SUBJECT: Waterford SES Unit No. 3  
Docket No. 50-382  
Significant Construction Deficiency No. 74  
"T&B Undersized Socket Welds"

Subject: LOUISIANA POWER & LIGHT COMPANY  
WATERFORD SES - UNIT NO. 3  
NCR 7680 IMPACT ON SCD 74; SCHEDULE 80  
UNDERSIZE SOCKET WELDS

REPORT NO. 103-7680

UNDERSIZE WELDS LINE 3002-240A

FIELD ENG. CL. Smith DATE 4/12/84 AREA \_\_\_\_\_ SYS. \_\_\_\_\_  
 DRAVO ISO NO. LW3-CC-47 PLAN DWG NO. \_\_\_\_\_ SPOOL SK. NO. \_\_\_\_\_  
 REV'D PER \_\_\_\_\_ REVIEWED BY \_\_\_\_\_ PROJ. ENG. \_\_\_\_\_

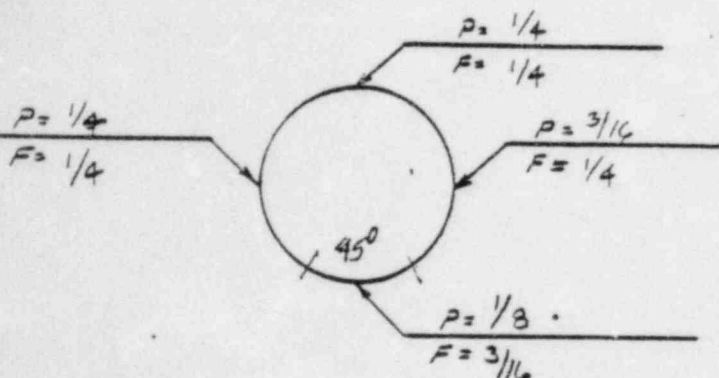
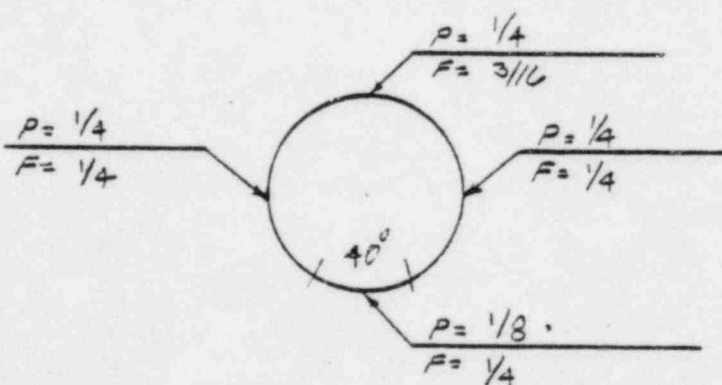
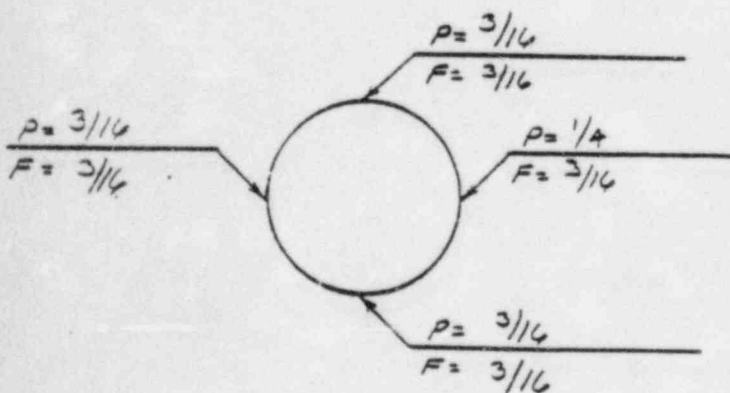
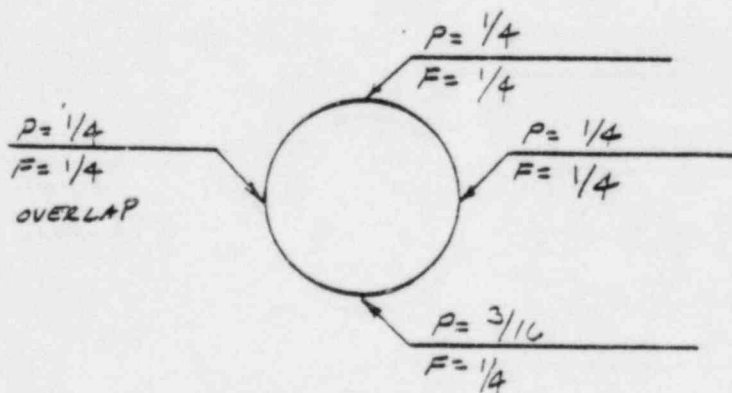
WELD NO. SW-31  
 EL. LOOKING WEST

WELD NO. SW 30  
 EL. LOOKING N.E.

WELD NO. SW 29  
 EL. LOOKING N.E.

WELD NO. SW 26

C<sub>x</sub> = 0.144 & THROAT = 0.089 SHALL BE SATISFIED FOR SW-3, 6, 30, 31, 37,  
& 38 PER ANALYSIS OF WORST CASE BASIS (5/16/83 MEMO FROM A. SHAMAN TO)

FIELD ENG. Goodland DATE 4-12-84 AREA \_\_\_\_\_ SYS. \_\_\_\_\_  
 DRAVO ISO NO. LW3-CC-47 PLAN DWG NO. \_\_\_\_\_ SPOOL SK. NO. \_\_\_\_\_  
 REV'D PER \_\_\_\_\_ REVIEWED BY \_\_\_\_\_ PROJ. ENG. \_\_\_\_\_

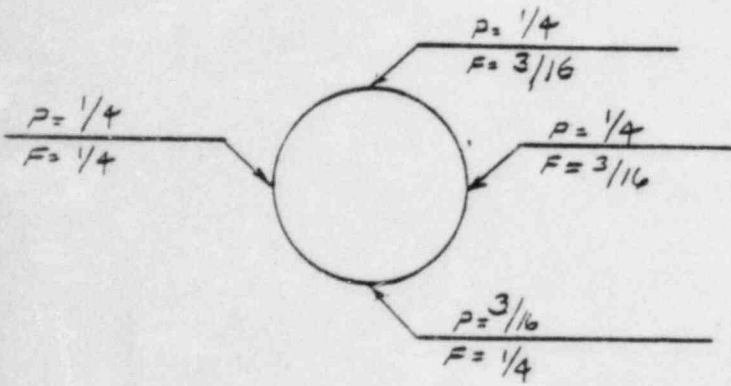
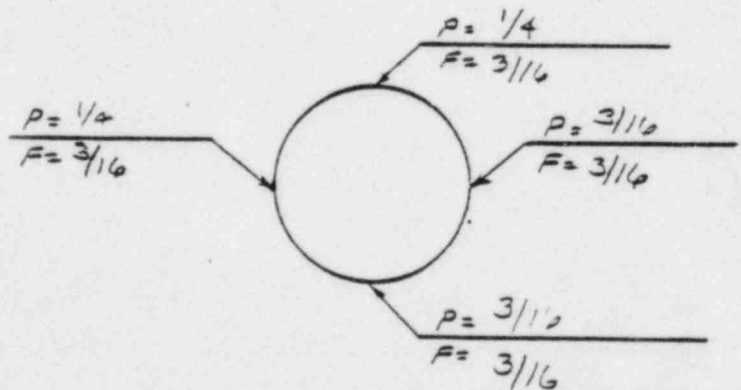
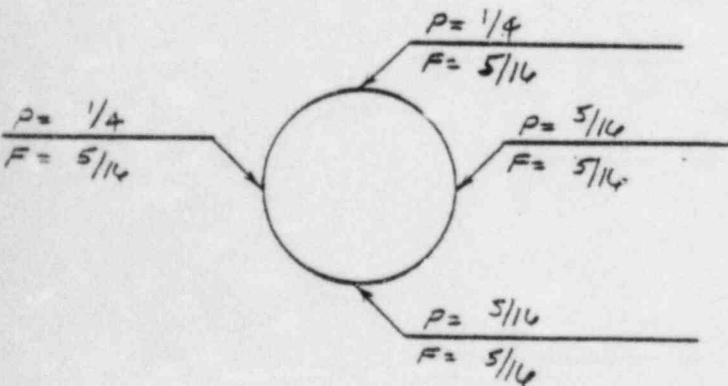
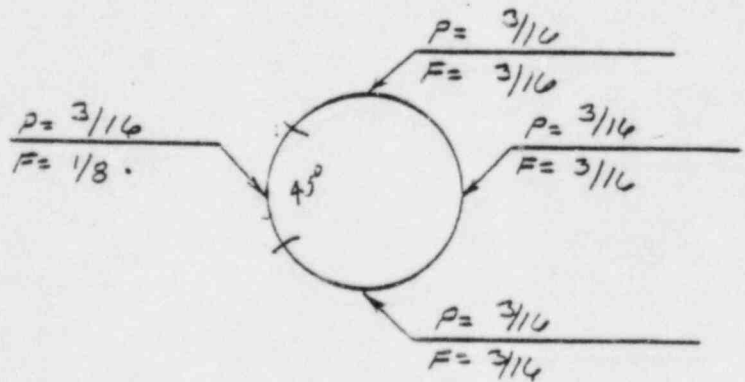
WELD NO. FW-L  
 EL. LOOKING NORTH

WELD NO. FW-4  
 EL. LOOKING SOUTH

↑N WELD NO. SW-1

WELD NO. SW-3

DRAVO ISO NO. LW3-CC-47 PLAN DWG NO. \_\_\_\_\_ SPOOL SK. NO. \_\_\_\_\_

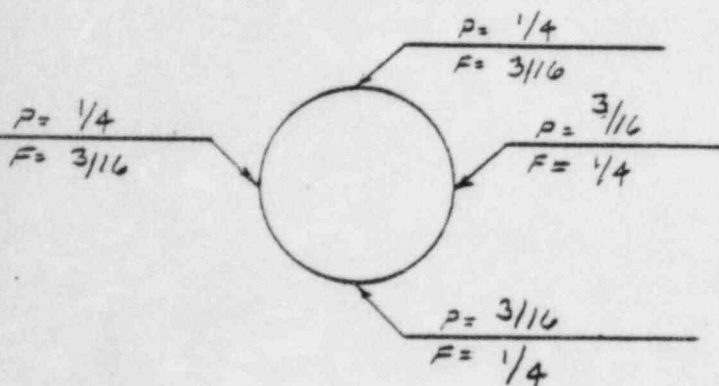
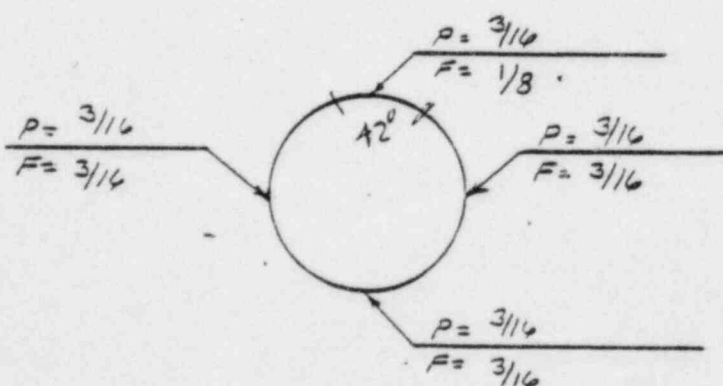
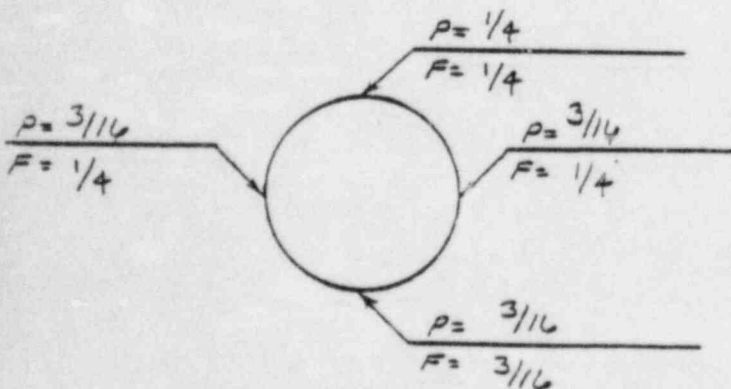
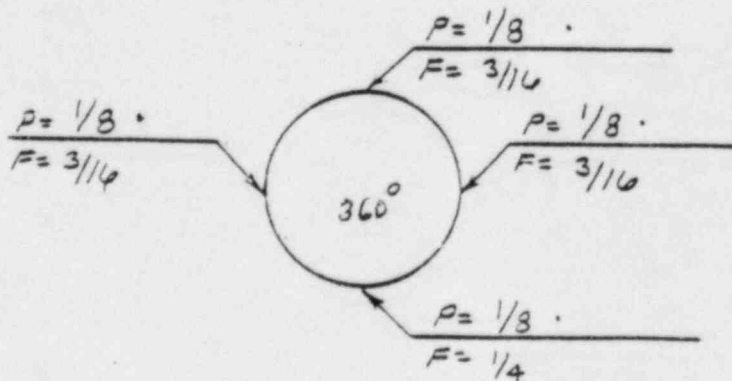
WELD NO. FW-2  
EL. LOOKING S.W.

WELD NO. SW-6  
EL. LOOKING NORTH

WELD NO. SW-39

WELD NO. SW-38

FIELD ENG. Chadwick DATE 4-12-84 AREA \_\_\_\_\_ SYS. SHT. 90=4  
 DRAVO ISO NO. LW3-CC-47 PLAN DWG NO. \_\_\_\_\_ SPOOL SK. NO. \_\_\_\_\_  
 REV'D PER \_\_\_\_\_ REVIEWED BY \_\_\_\_\_ PROJ. ENG. \_\_\_\_\_

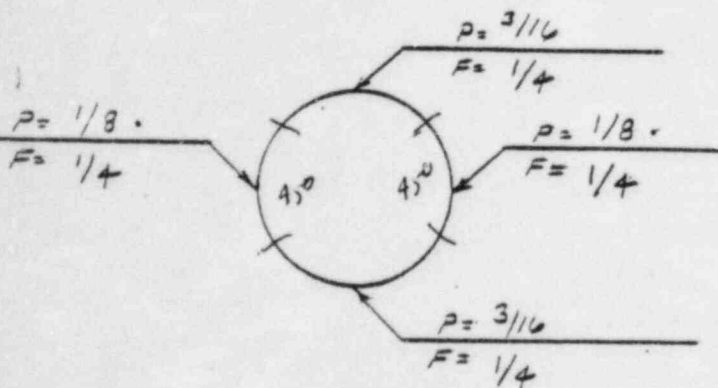
WELD NO. SW-37  
 PLAN

CLIENT L. P. & L.PROJECT WATERFORD SES UNIT IIISUBJECT NCR-W3-7680, E2804-AC-1C-1222, G-857, 503NCR-W3-7680 ATTACHMENT 5

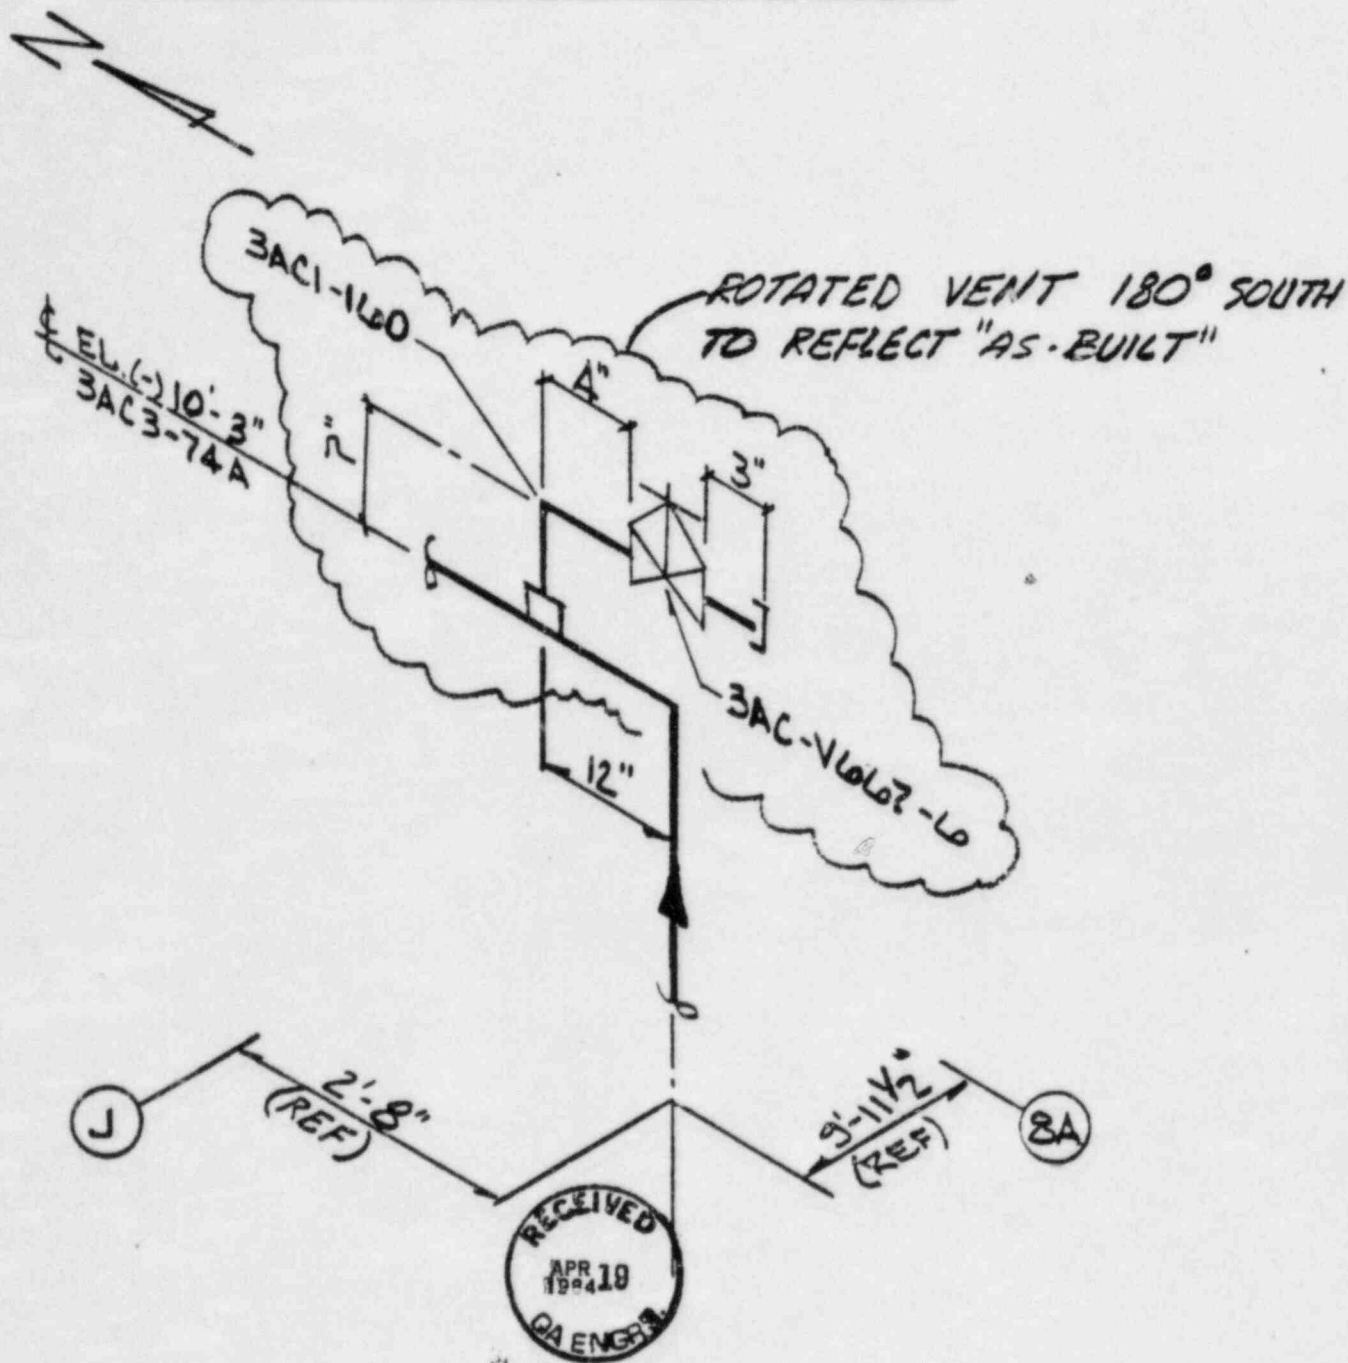
Detail "A" for vent line is oriented 180° to the isometric drawing.

Field verification verifies this to be true, recommend drawing to be redlined to show this.
